**Site Plan Review Committee (SPRC)**  
**Staff Report for Wells Fargo/Verizon (3140**  
**Washington Blvd. & 1025 N. Irving St.)**

**DATE:** February 27, 2023  
**PLACE:** 2100 Clarendon Blvd.

**Item 1. SPLN22-00002**  
**Wells Fargo/Verizon**  
(RPC# 19004012; 19004005; 19004011; 19004008)  
Planning Commission and County Board meetings to be determined.  
*Peter Schulz (CPHD Staff)*

Figure 6-- Courtesy Applicant

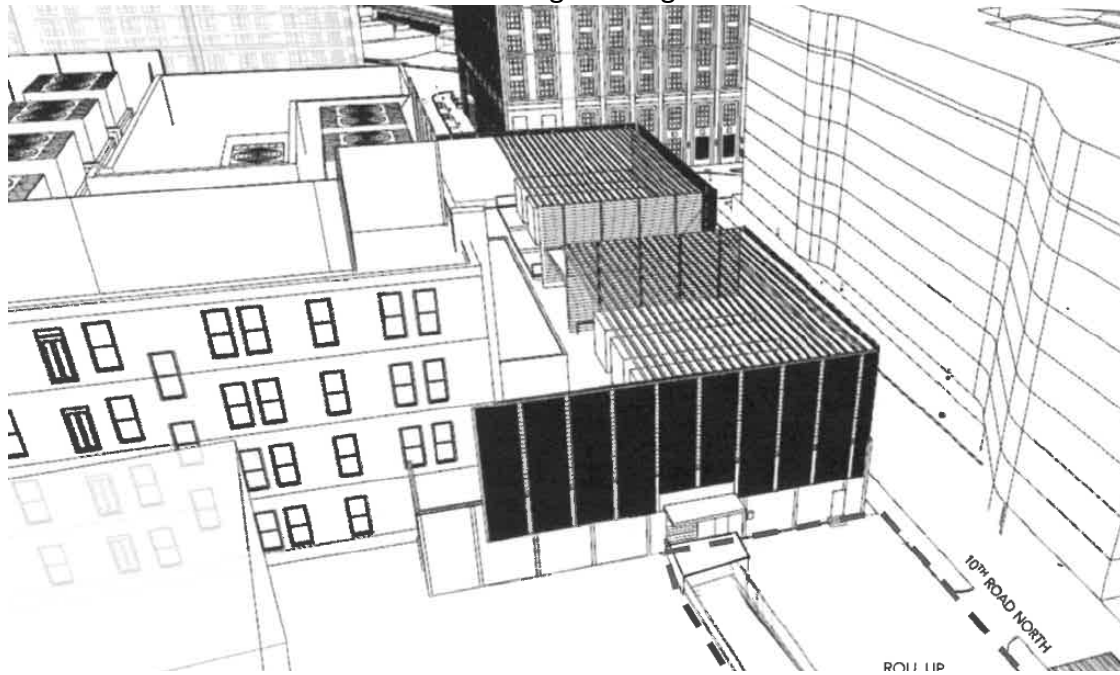
- Architecture/Urban Design: The developer and Verizon propose mechanical screening on the Verizon building. Staff would like to see other aesthetic improvements to the one-story, windowless 1970s Verizon addition.

- Architecture/Urban Design: Mechanical screening needs to be set back an equivalent distance to its height from the edge of the roof.
- Public Space/Landscaping: The proposed 10<sup>th</sup> Road North streetscape does not comply with the Zoning Ordinance requirements and good urban design practice—~~there are no street trees~~, an inconsistent sidewalk width, and sidewalk “jogging” created by the desire for the drive through ATM.

Figure 8-- 10th Road civil Plans

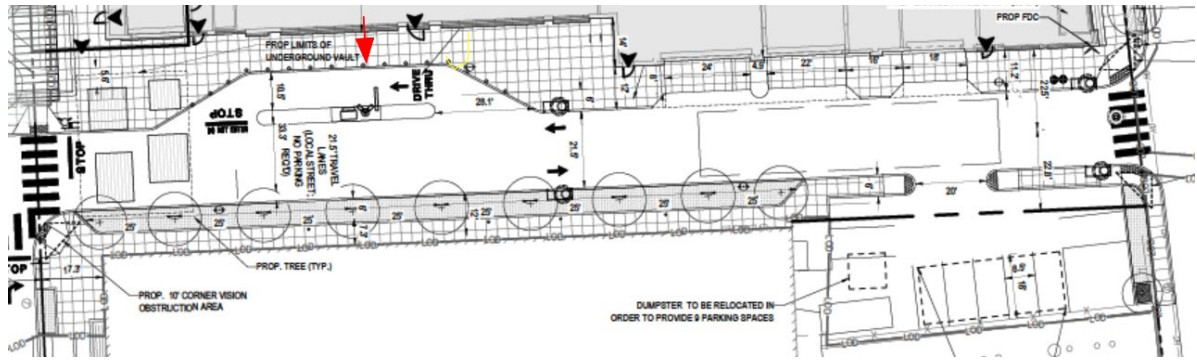
- Transportation: The presence of the drive-through creates a sub-optimal experience for pedestrians on the North Side of 10<sup>th</sup> Road, including ~~lack of street trees~~ and a jog in the path.

- Transportation: The Sector Plan envisions 10<sup>th</sup> Road as a local street with parking on at least one side of the street. Currently 10<sup>th</sup> Road looks more like an alley.
